**Re:** Rock Spring Urban Design Guidelines  
Comments on behalf of Erickson at Rock Spring – 10400 Fernwood Road

Re: Comments on Parking Lots to Places – Urban Design Guidelines for Rock Spring  
& White Flint 2 Sector Plans (Draft March 2019)

RE: Urban Design Guidelines for Rock Spring and White Flint 2 Sector Plans;  
Comments re Loehmann's Plaza Site Related Recommendations (Randolph Hills  
District); 5200-5290 Randolph Road

Comments Regarding Proposed Rock Spring Sector Plan Urban Design Guidelines

**Figure 3.19: Rock Spring Central Concept Diagram**

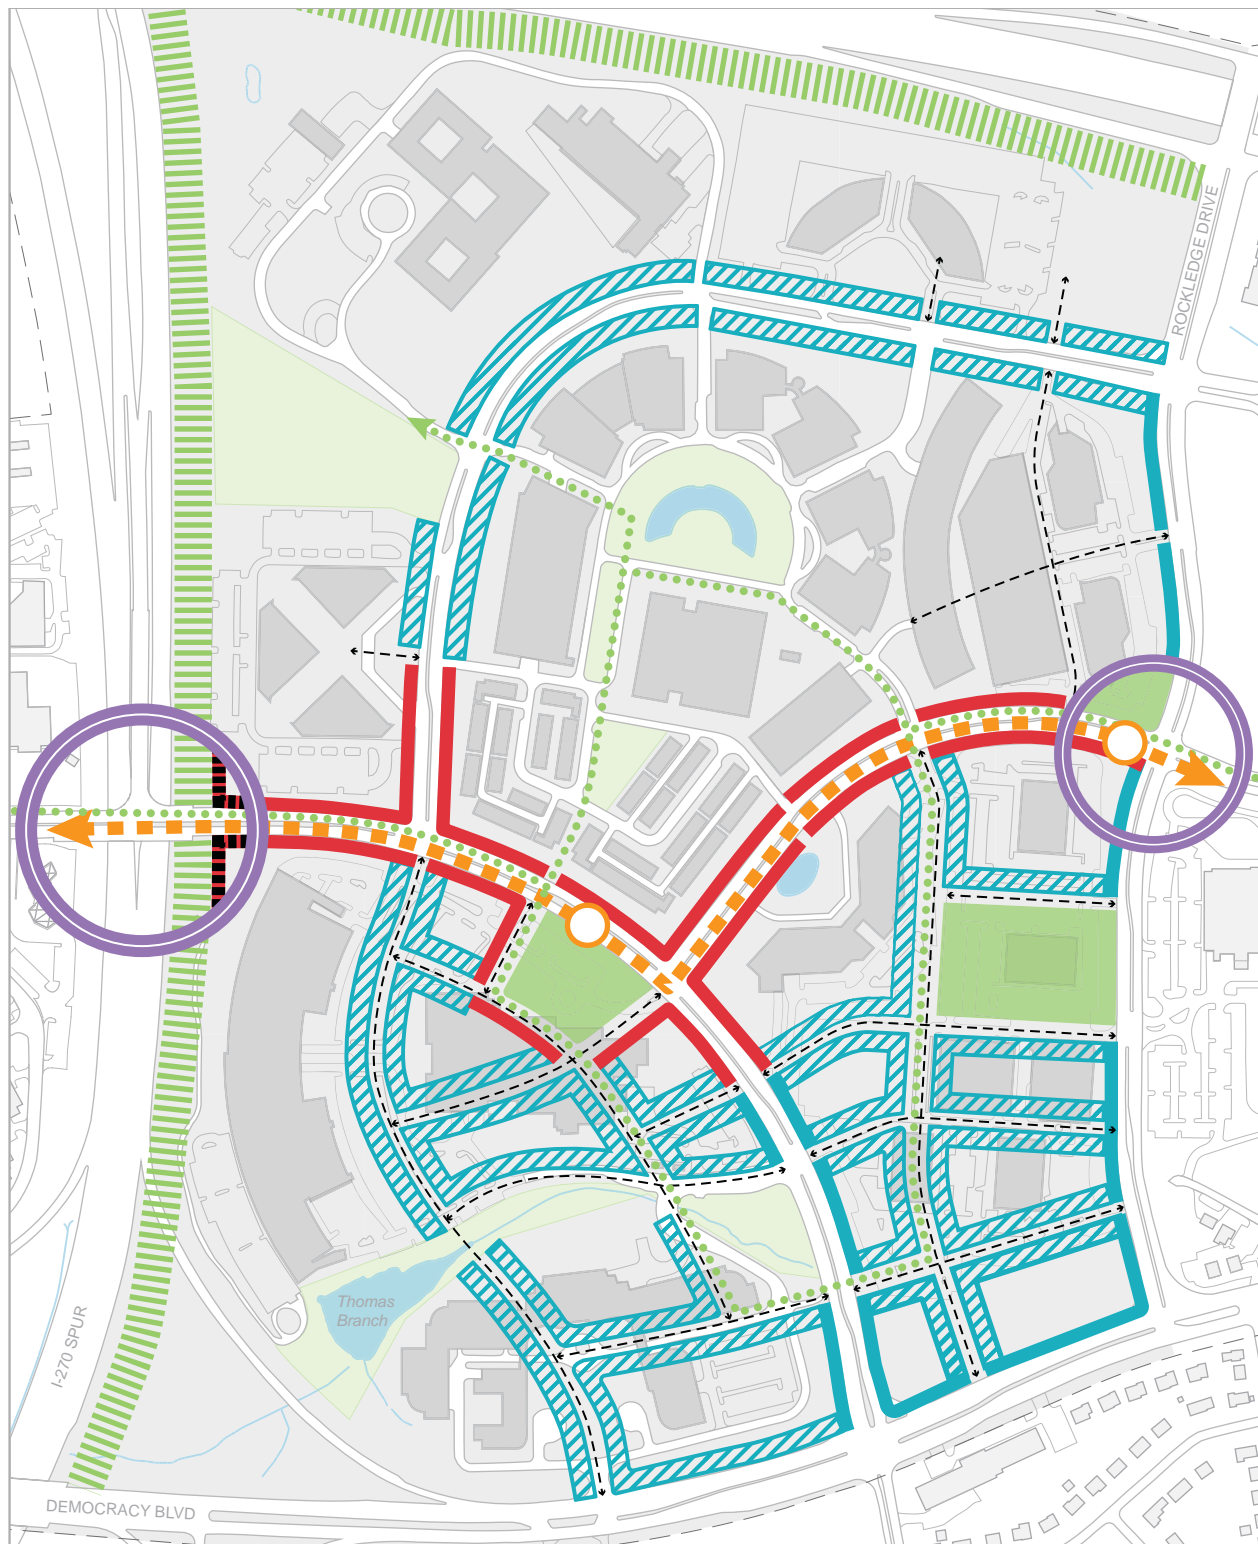
We appreciate the “Note” added to Figures 3.19, 3.20 and 3.21 and other Figures throughout the Design Guidelines stating that the Figures are intended for illustrative purposes only as it relates to site and building design. It is important to specify that the placement of the open spaces is also illustrative. The ultimate location of open space will be dictated by numerous factors. As noted above, in the case of a CCRC, the program ultimately drives the design, and the location of a sizable amount of open space, such as is required on the Property, can greatly influence the layout of the project.

8. We are concerned about the recommendation regarding the interim recreational field and would request that it be removed from the Guidelines.
9. P. 57 - Figure 3.19, there is a reference to a “Built to area.” What is this and where is it used? Also, what is the “Potential Gateway” reference?

Figure 3.9: Recommendations for major parks and open spaces within the Plan area

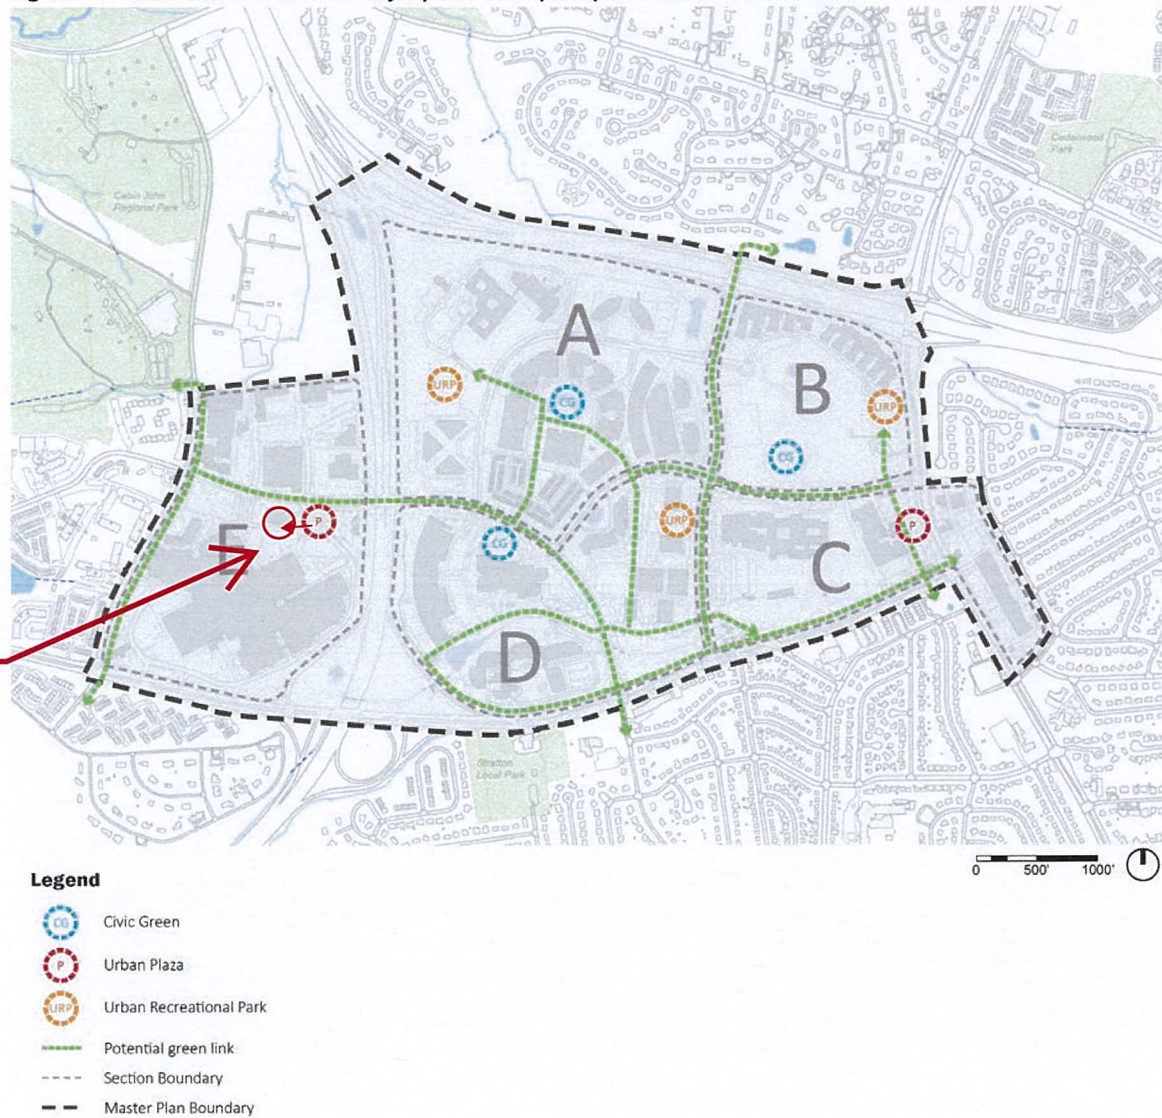
SHIFT PLAZA LOCATION

2. URW has worked closely with Staff to provide access to the Property off of Westlake Terrace while respecting the streetscape and aligning with the streets north of Westlake Terrace. The solution does not involve extending either Autopark Avenue or Motor City Drive through the Property and thus we recommend that the second bullet on page 72 be deleted. In addition, the Project does not provide any public streets (the ground plain is above the parking structure) and therefore the Design Guidelines should clarify the status of the internal access ways.
3. The images on Figures 3.33 and 3.34 should be replaced with the URW images and the location of heritage gardens (the civic green) should be accurately located on Figure 3.9.

Figure 3.30: Rock Spring West Concept Diagram

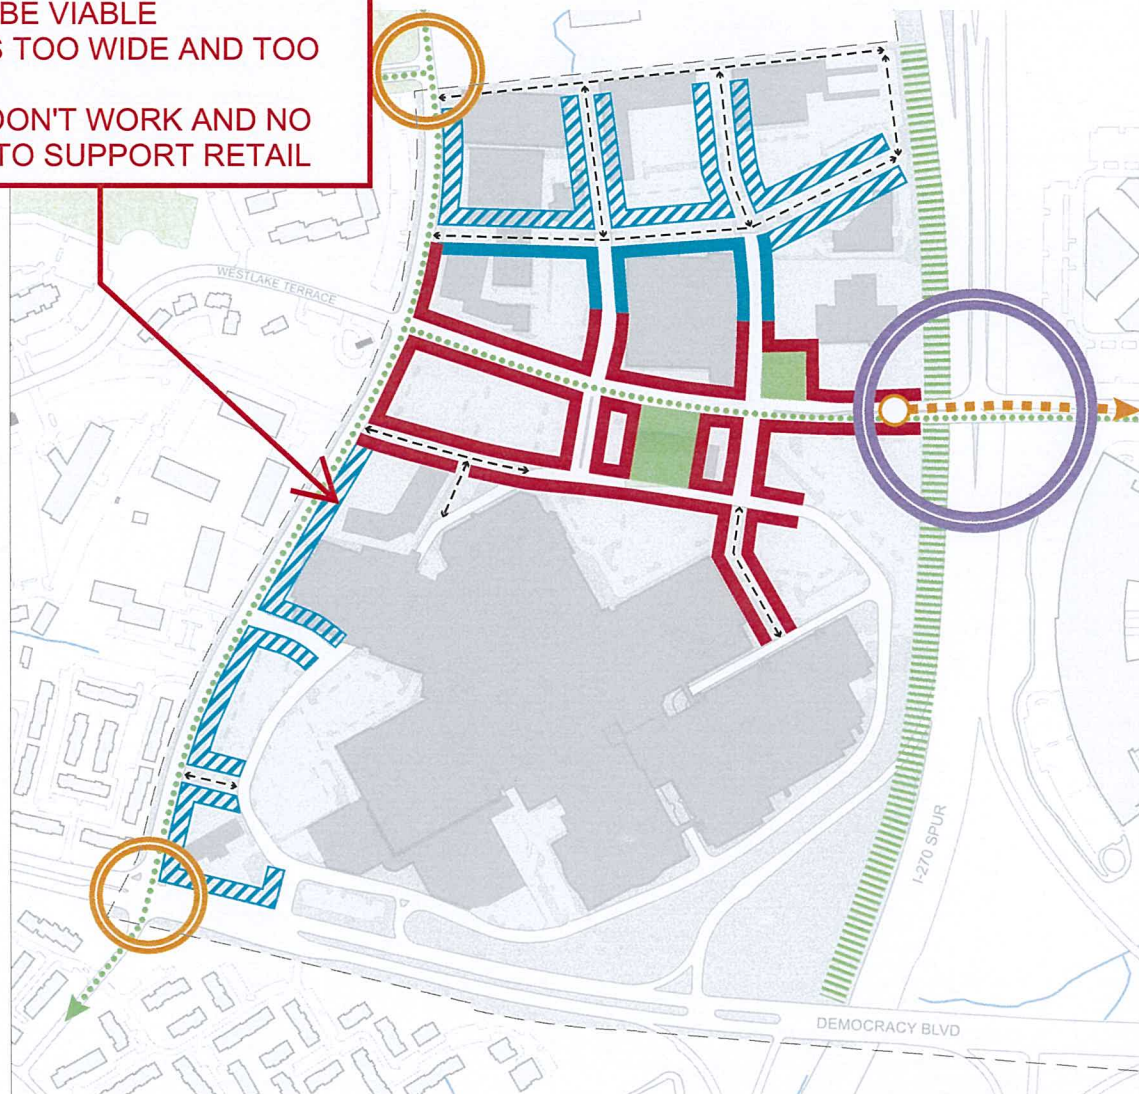
STREET FRONTING RETAIL HERE  
WILL NOT BE VIABLE  
STREET IS TOO WIDE AND TOO  
BUSY  
GRADES DON'T WORK AND NO  
PARKING TO SUPPORT RETAIL

1. Figures 3.30 and 3.34 (pages 69 and 73) – The images show a build-to line along Westlake Drive. URW recommends that this build-to line be eliminated. The grades of the Property are too high to orient any building toward Westlake Drive. Moreover, the majority of this frontage area is owned in fee by Macy's, with a separate entity unrelated to URW owning the gas station at the corner, and thus

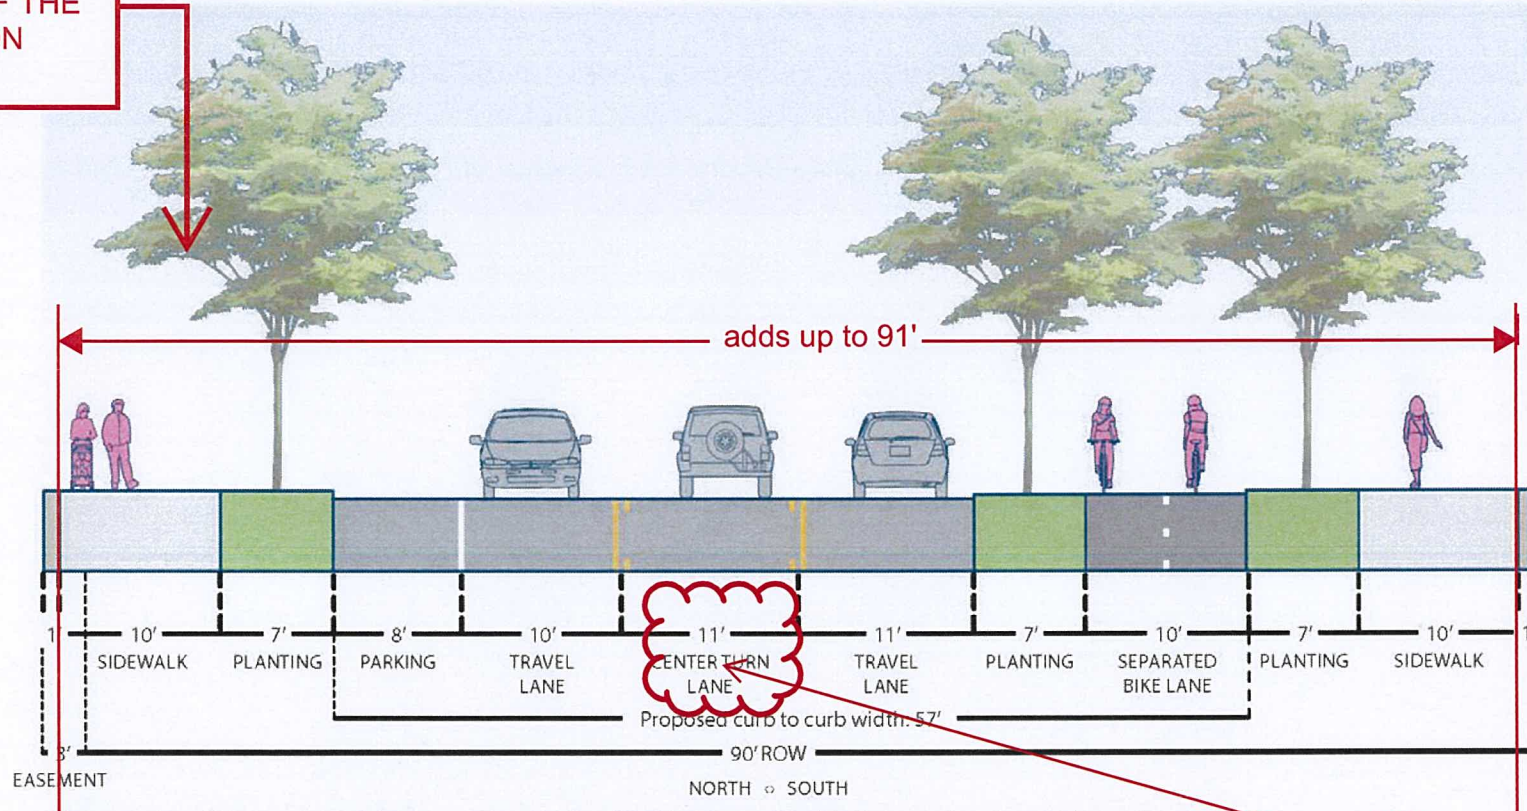
THIS SHOULD BE THE MALL SIDE OF THE SECTION

Westlake Drive to Bells Mill Road

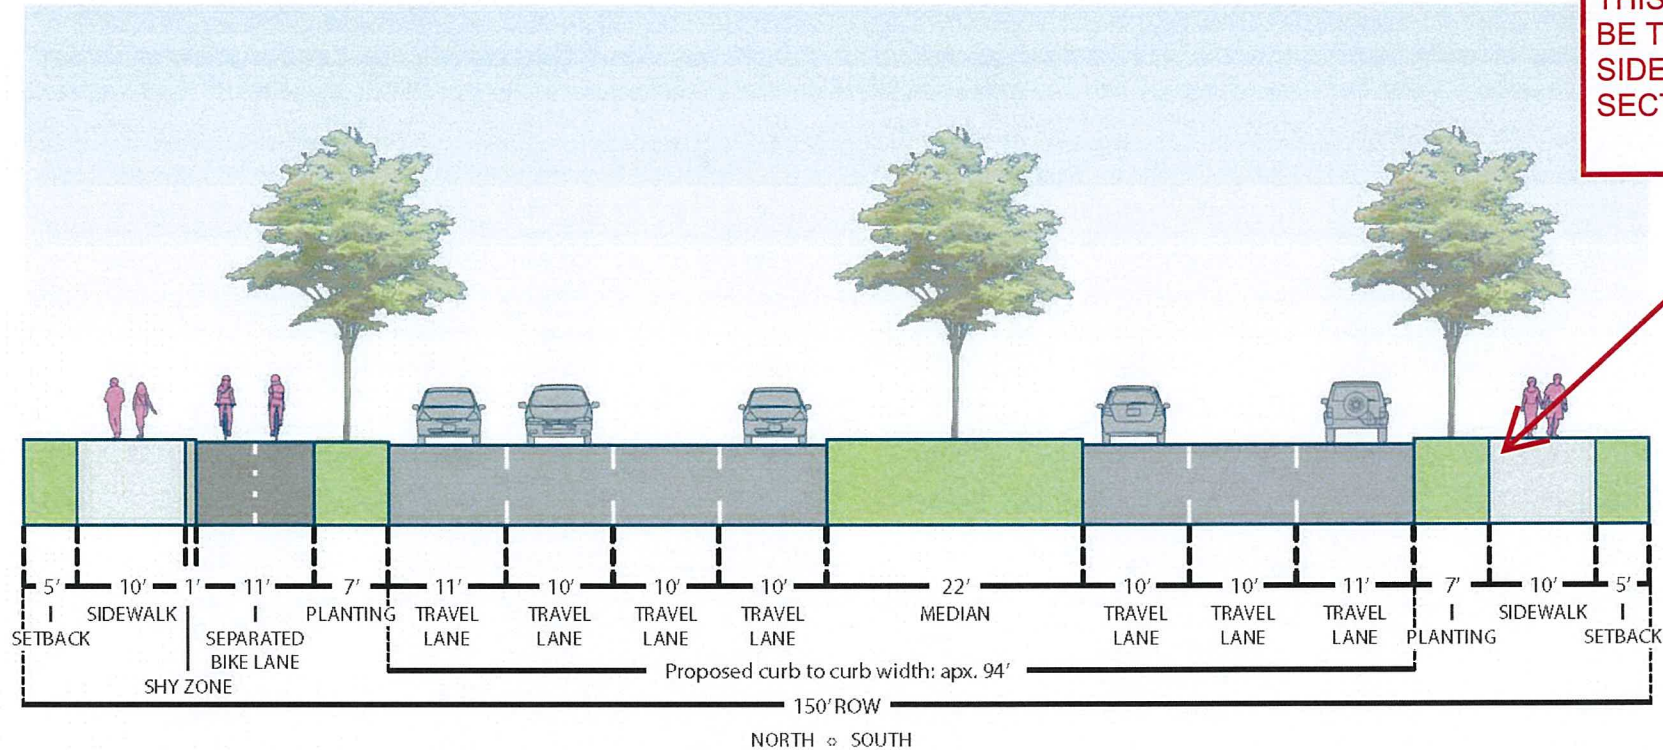
THIS SHOULD  
BE THE MALL  
SIDE OF THE  
SECTION

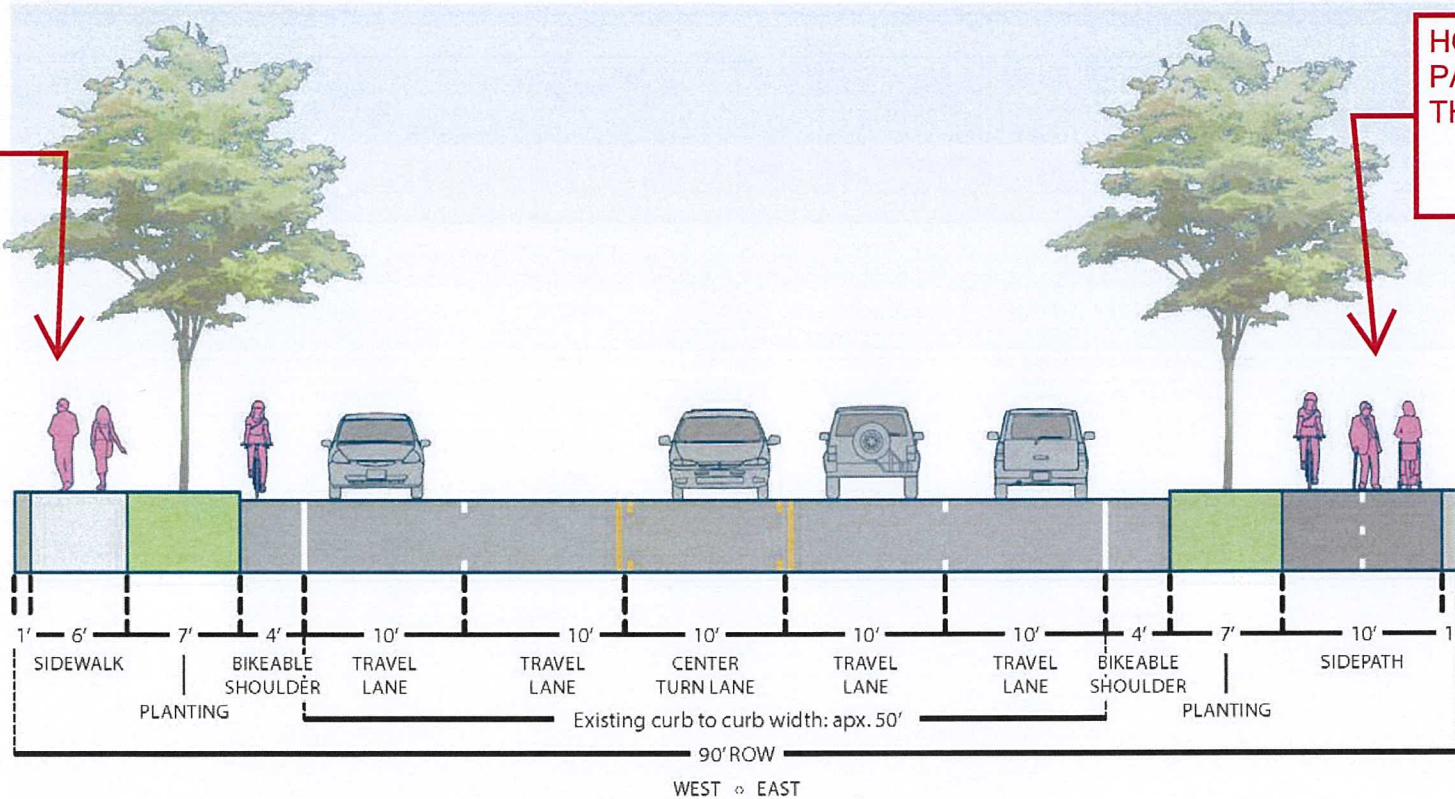
THIS SHOULD  
BE THE MALL  
SIDE OF THE  
SECTION

HOMES AND  
PARK ARE ON  
THIS SIDE

Figure 4.44: Map 5.2.5: Randolph Hills District - Design Elements Diagram

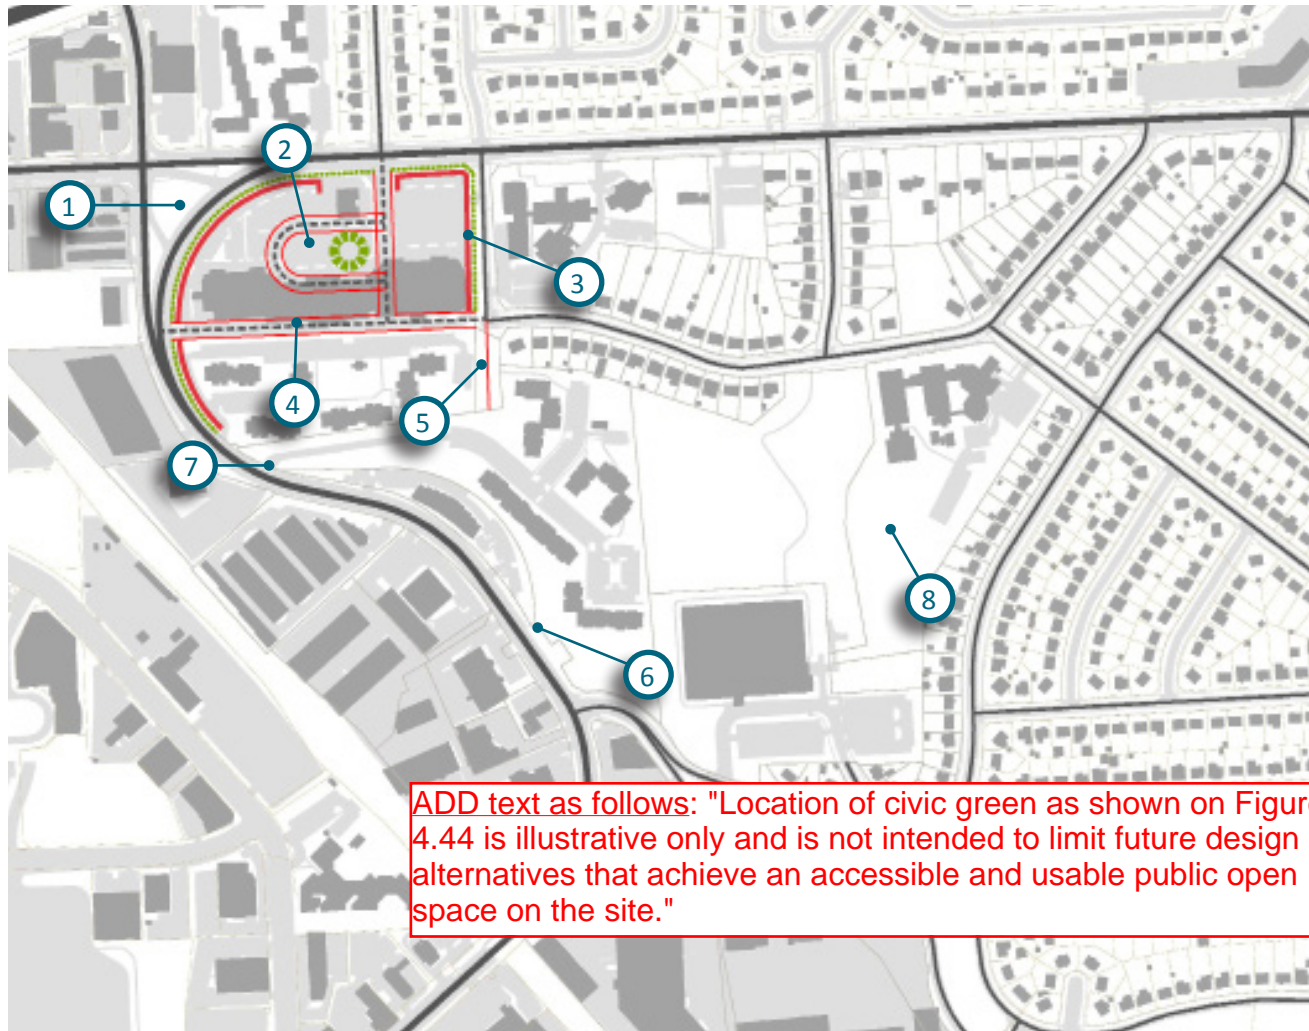
- a. The terms “central” and “centralized” are locational in nature and quite specific such that when coupled with the depiction on Figure 4.44 on page 103, could be interpreted more literally in the future to restrict consideration of other possible alternatives as discussed herein.

Replace with  
"usable"

ADD text as follows: "Location of civic green as shown on Figure 4.44 is illustrative only and is not intended to limit future design alternatives that achieve an accessible and usable public open space on the site."

Figure 4.45: Loehmann's Plaza - Potential Development

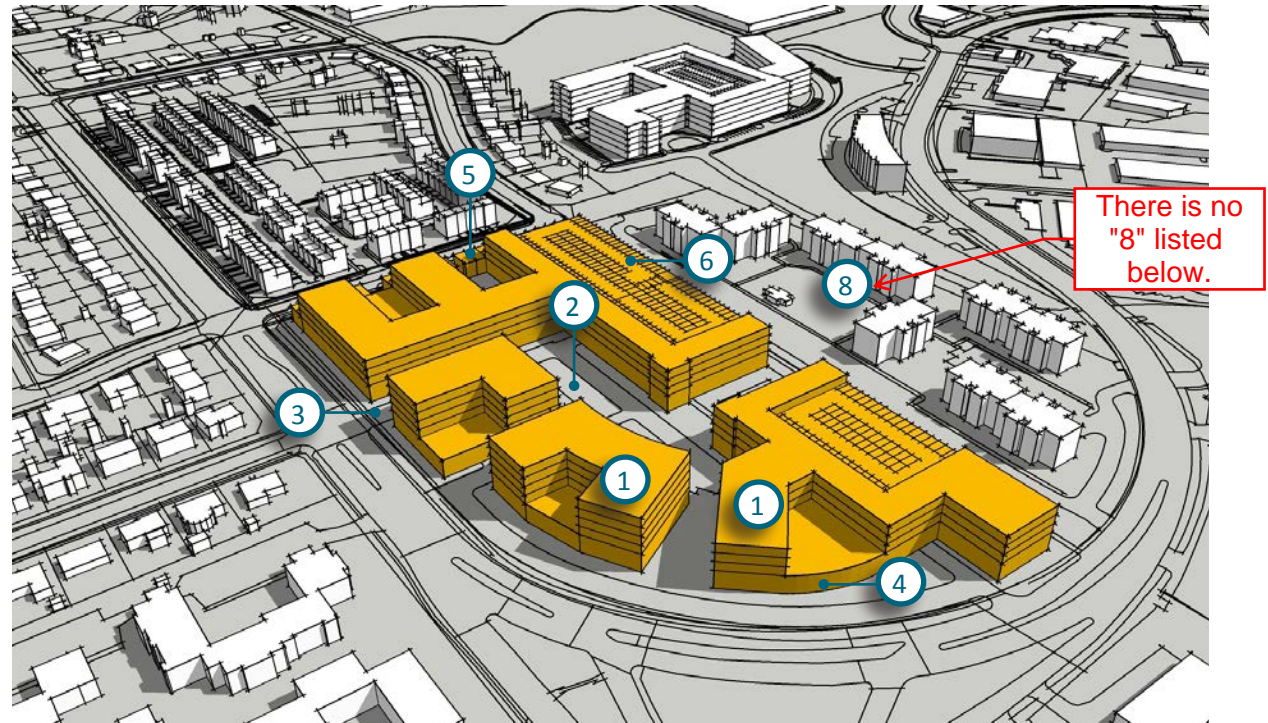
Replace with  
"usable"

1. Maximum building height in this area- corner of Randolph Rd. and Parklawn Drive.
2. Provide an accessible and ~~centralized~~ public open space.
3. Create through streets to improve connectivity; align with existing streets if possible.
4. Activate frontages along pedestrian areas.
5. Redevelopment should transition in scale to residential adjacent communities.
6. Conceal parking structures.

Replace with  
"usable"
